REVISION TRANSMITTAL

INDICATING/RECORDING SYSTEMS - POTENTIOMETER REPLACEMENT

The CM41172 Potentiometer is obsolete and is replaced with the KS4U1031F28 Potentiometer.

MTB-31-03
Page 1 of 18

Figure 1. Potentiometer Replacement (Sheet 1)

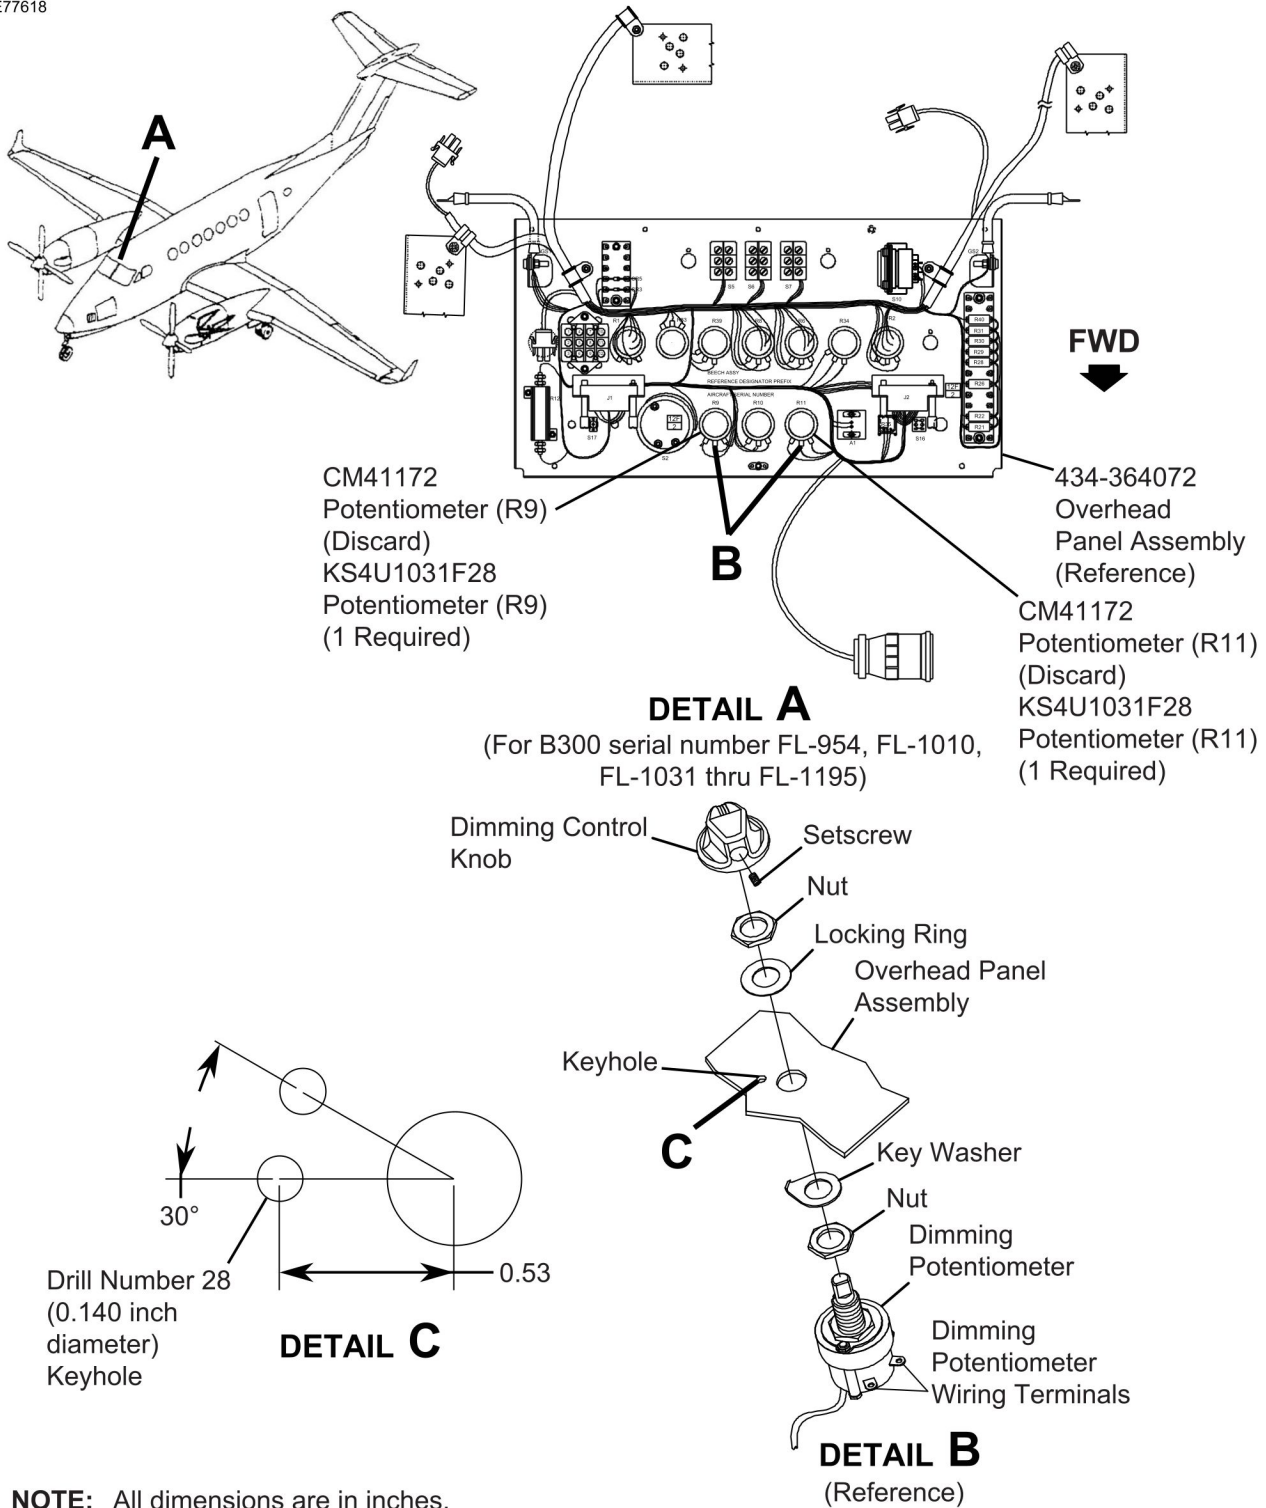
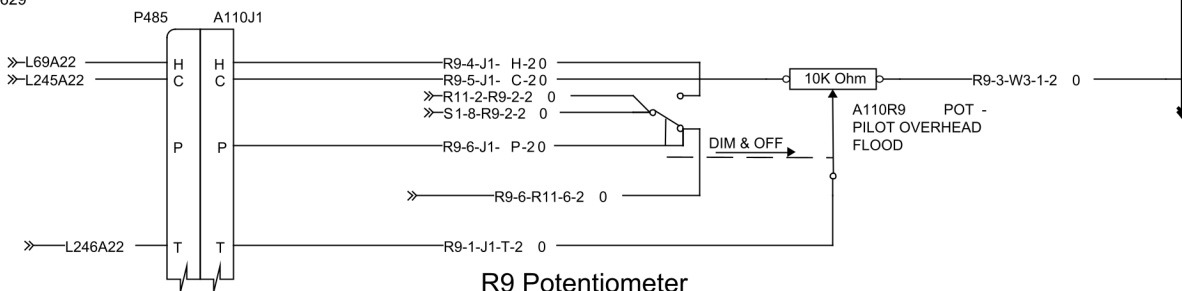
- B. (Refer to Figure 1, Sheet 1 Detail C.) Drill the new keyholes into the 434-364072 Overhead Panel as follows:
- (1) Locate and drill the two Number 28 (0.140 inch diameter) holes into the overhead panel

- C. (Refer to Figure 1, Sheet 1, Detail B.) Install the two KS4U1031F28 Potentiometers into the 130M365002-011 Overhead Panel as follows:
- (1) Install the kept nut and the key washer onto the two KS4U1031F28 Potentiometers.

Figure 1. Potentiometer Replacement (Sheet 2)

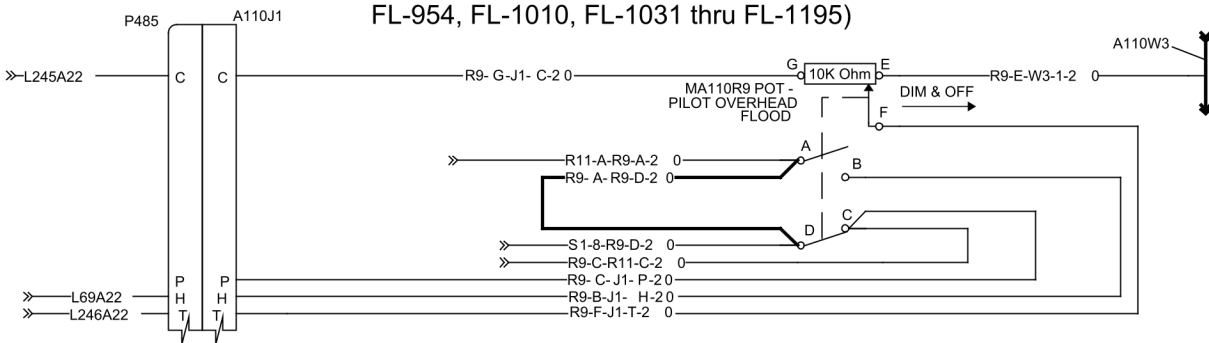
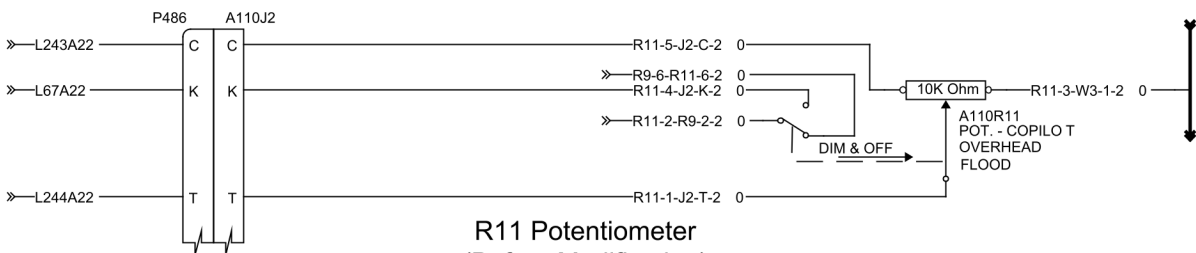
- D. (Refer to Figure 1, Sheet 2.) Add and re-locate the wires to the R9 KS4U1031F28 Potentiometer as shown in Figure 1 Sheet 2.
- (1) If the wiring to the new potentiometer needs to be extended then do as follows:
NOTE: It may be necessary to install M81824/1-2 Splices and M22759/16-20-9 Electrical Wire to extend the wires to reach the terminal lugs.

- E. (Refer to Figure 1, Sheet 2.) Add and re-locate the wires to the R11 KS4U1031F28 Potentiometer as shown in Figure 1 Sheet 2.
- (1) If the wiring to the new potentiometer needs to be extended then do as follows:
NOTE: It may be necessary to install M81824/1-2 Splices and M22759/16-20-9 Electrical Wire to extend the wires to reach the terminal lugs.

**R9 Potentiometer
(Before Modification)**
(Model B300 serial number
FL-954, FL-1010, FL-1031 thru FL-1195)

**R9 Potentiometer
(After Modification)**
(Model B300 serial number
FL-954, FL-1010, FL-1031 thru FL-1195)

**R11 Potentiometer
(Before Modification)**
(Model B300 serial number
FL-954, FL-1010, FL-1031 thru FL-1195)

**R11 Potentiometer
(After Modification)**
(Model B300 serial number
FL-954, FL-1010, FL-1031 thru FL-1195)

Figure 1. Potentiometer Replacement (Sheet 3)

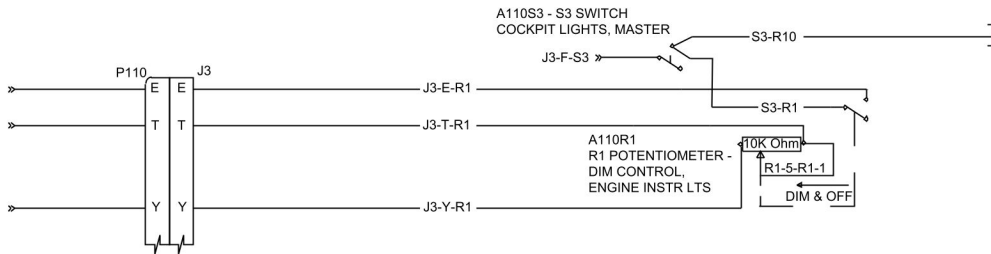
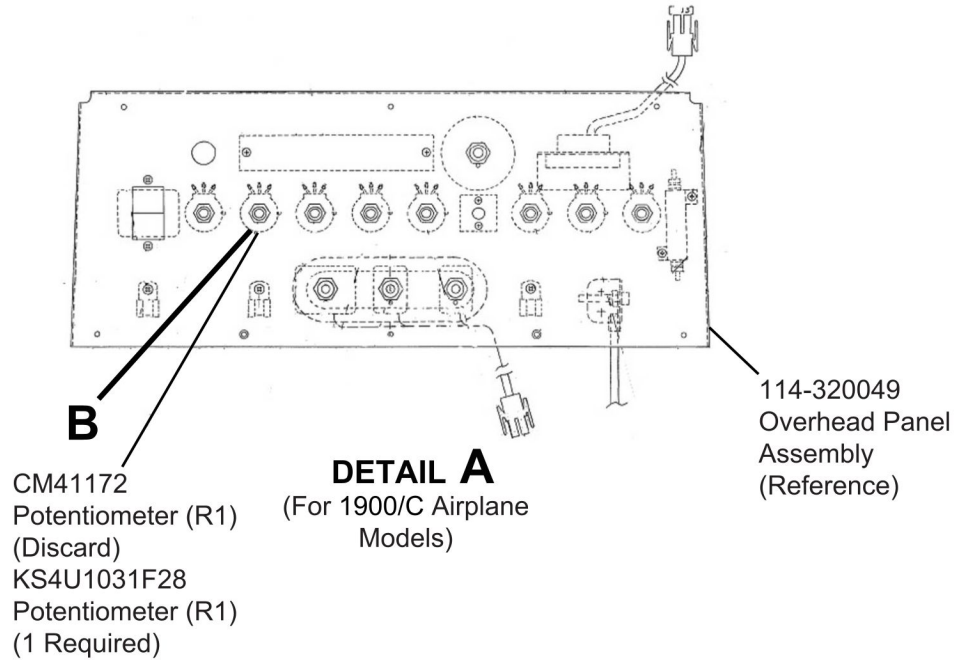
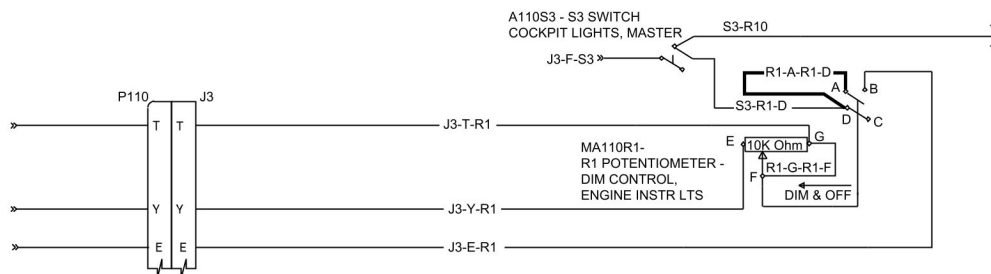
- D. (Refer to Figure 1, Sheet 3.) Add and re-locate the wires to the R1 KS4U1031F28 Potentiometer as shown in Figure 1 Sheet 3.

R1 Potentiometer
 (Before Modification)
 (Model 1900/C Airplanes)

R1 Potentiometer
 (After Modification)
 (Model 1900/C Airplanes)

Figure 1. Potentiometer Replacement (Sheet 4)

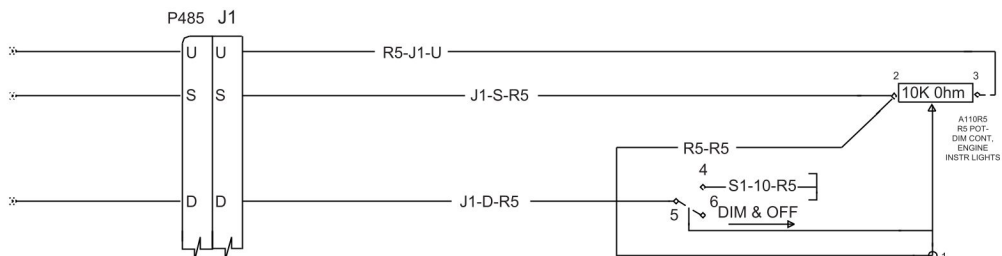
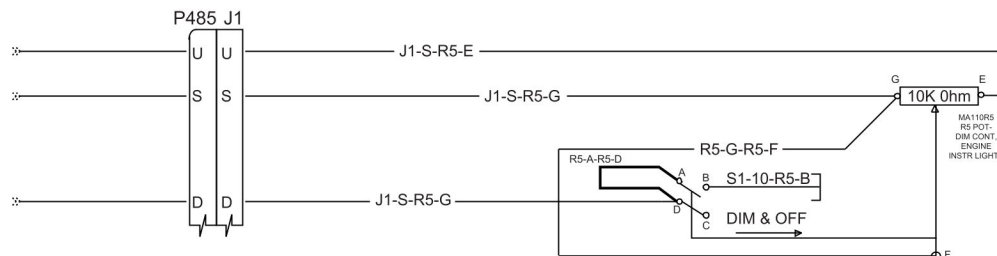
- C. (Refer to Figure 1, Sheet 4.) Add and re-locate the wires to the R5 KS4U1031F28 Potentiometer as shown in Figure 1 Sheet 4.
- (1) If the wiring to the new potentiometer needs to be extended then do as follows:
NOTE: It may be necessary to install M81824/1-2 Splices and M22759/16-20-9 Electrical Wire to extend the wires to reach the terminal lugs.

CM41172
 Potentiometer (R5)
 (Discard)
 KS4U1031F28
 Potentiometer (R5)
 (1 Required)

R9 Potentiometer
 (Before Modification)
 (For B300/B300C, 300/300LW
 Airplane Models)

R9 Potentiometer
 (After Modification)
 (For B300/B300C, 300/300LW
 Airplane Models)

Figure 1. Potentiometer Replacement (Sheet 5)

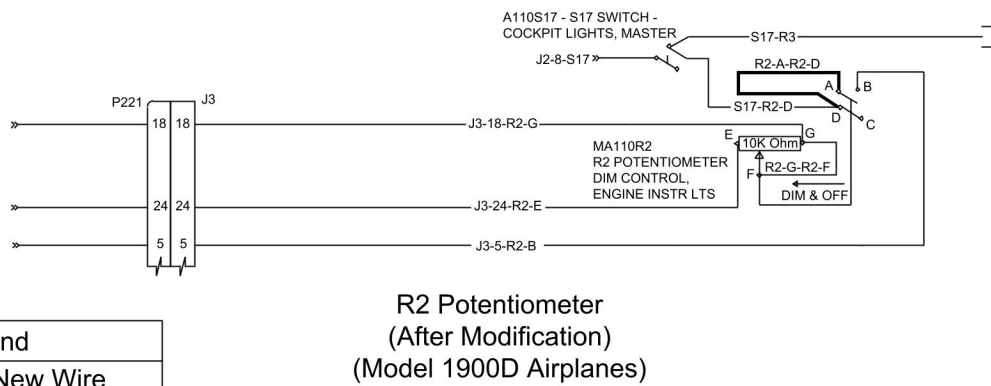
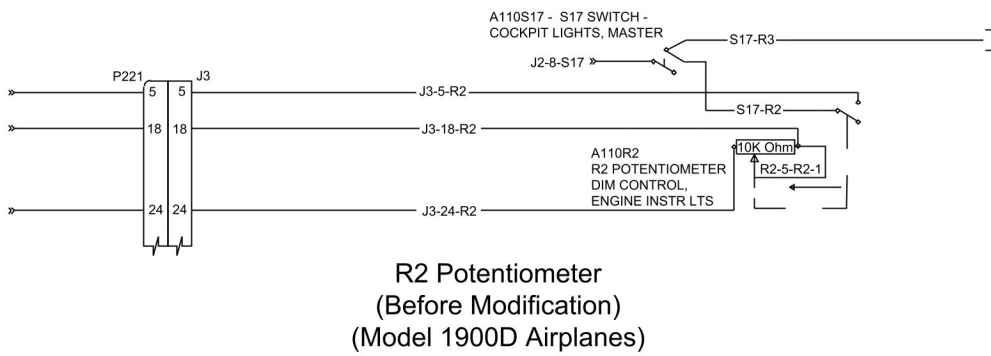
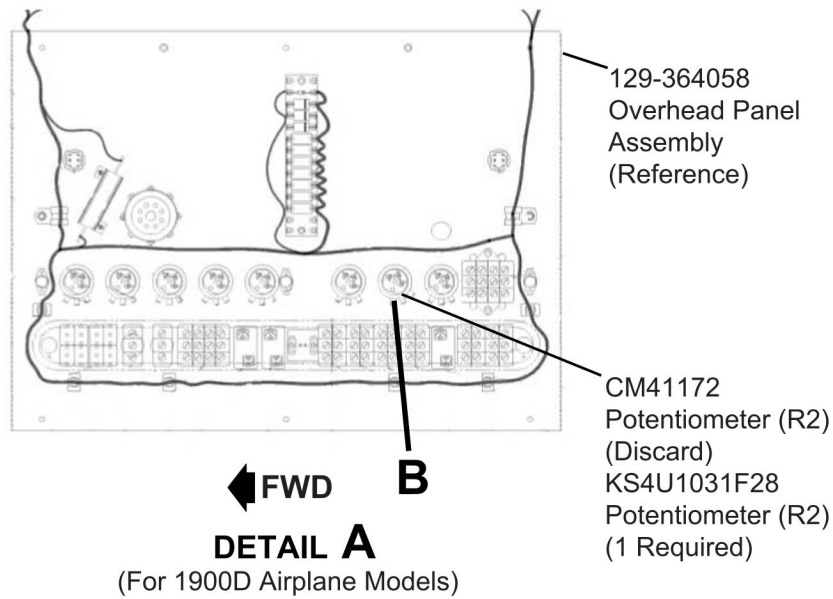
- D. (Refer to Figure 1, Sheet 5.) Re-locate the wires to the R2 KS4U1031F28 Potentiometer as shown in Figure 1 Sheet 5.
 - (1) If the wiring to the new potentiometer needs to be extended then do as follows:
NOTE: It may be necessary to install M81824/1-2 Splices and M22759/16-20-9 Electrical Wire to extend the wires to reach the terminal lugs.

Figure 1. Potentiometer Replacement (Sheet 6)

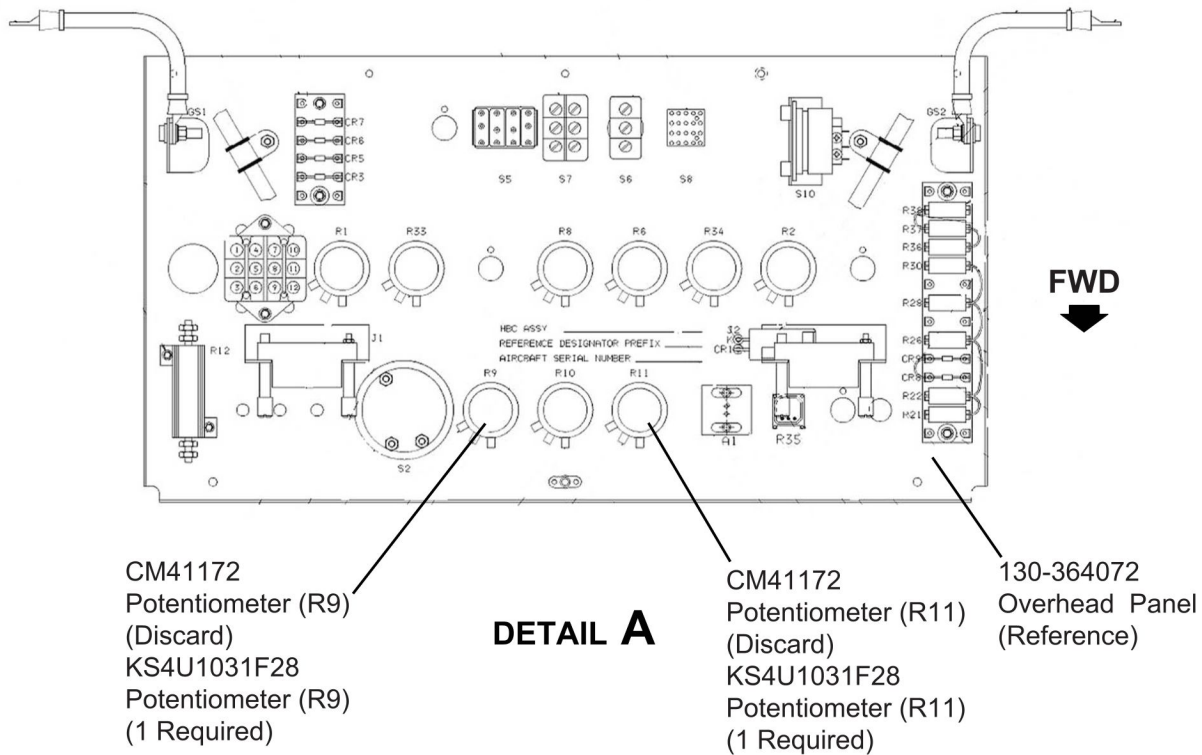
- E. Using an indelible marker, relabel the modified wire harness as 130M365002-0019.
 - F. Go to Step 10.
9. (Refer to Figure 1, Sheet 6 thru 8.) For B300 model airplanes with serial numbers FL-601, FL-672, FL-688 thru FL953, FL-955 thru FL-1009, FL-1011 thru FL-1030 and for B300C model airplanes with serial numbers FM-36 THRU FM-65, do as follows:

NOTE: This view only applies to B300 model airplanes with serial numbers FL-601, FL-672, FL-688 thru FL953, FL-955 thru FL-1009, FL-1011 thru FL-1030 and for B300C model airplanes with serial numbers FM-36 THRU FM-65.

Figure 1. Potentiometer Replacement (Sheet 7)

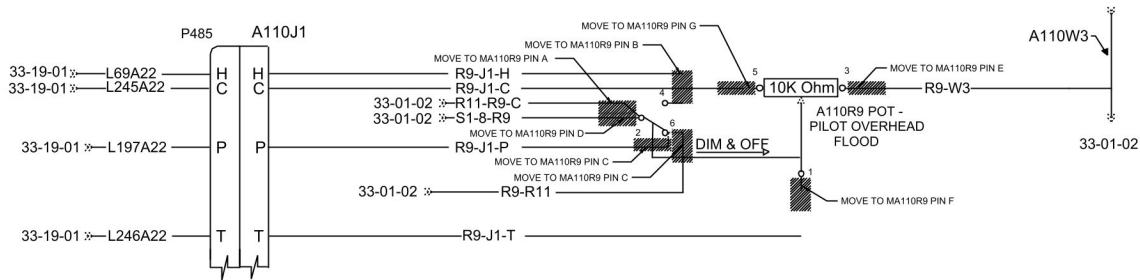
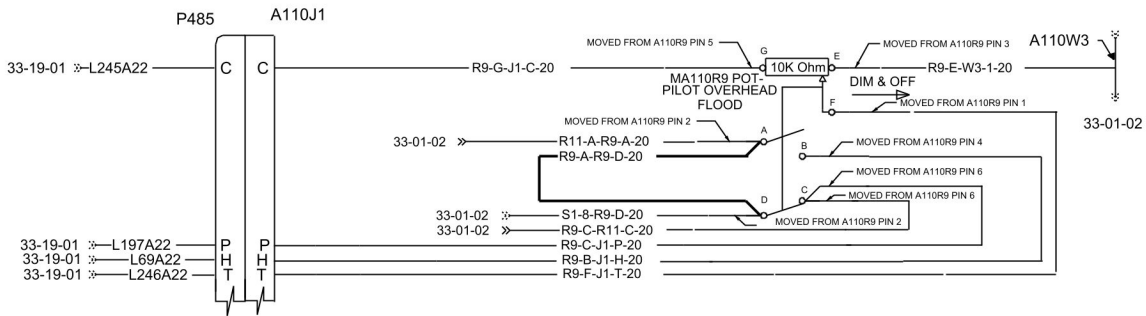
- D. (Refer to Figure 1, Sheet 7.) Add and re-locate the wires to the R9 KS4U1031F28 Potentiometer as shown in Figure 1 Sheet 7.
- (1) If the wiring to the new potentiometer needs to be extended then do as follows:
NOTE: It may be necessary to install M81824/1-2 Splices and M22759/16-20-9 Electrical Wire to extend the wires to reach the terminal lugs.

R9 Potentiometer
(Before Modification)

R9 Potentiometer
(After Modification)

Figure 1. Potentiometer Replacement (Sheet 8)

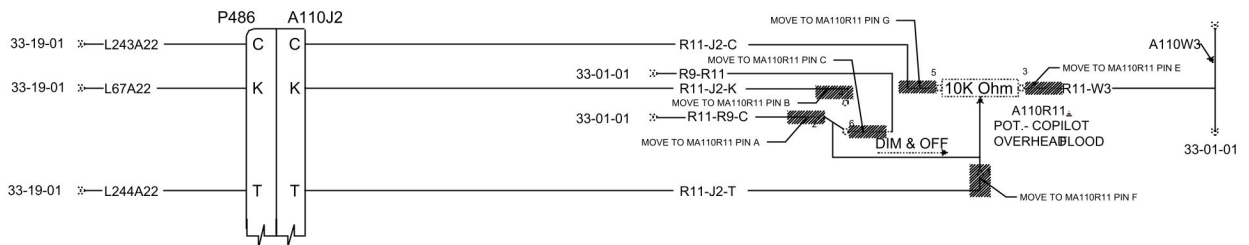
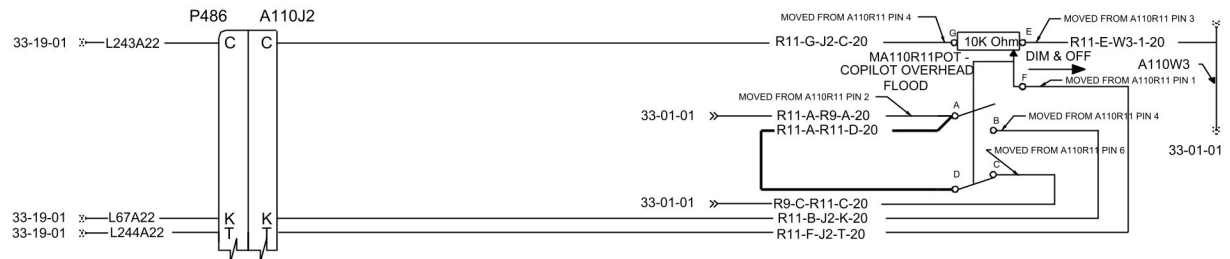
- E. (Refer to Figure 1, Sheet 8.) Add and re-locate the wires to the R11 KS4U1031F28 Potentiometer as shown in Figure 1 Sheet 8.
- (1) If the wiring to the new potentiometer needs to be extended then do as follows:
NOTE: It may be necessary to install M81824/1-2 Splices and M22759/16-20-9 Electrical Wire to extend the wires to reach the terminal lugs.

R11 Potentiometer
 Before Modification

R11 Potentiometer
 After Modification
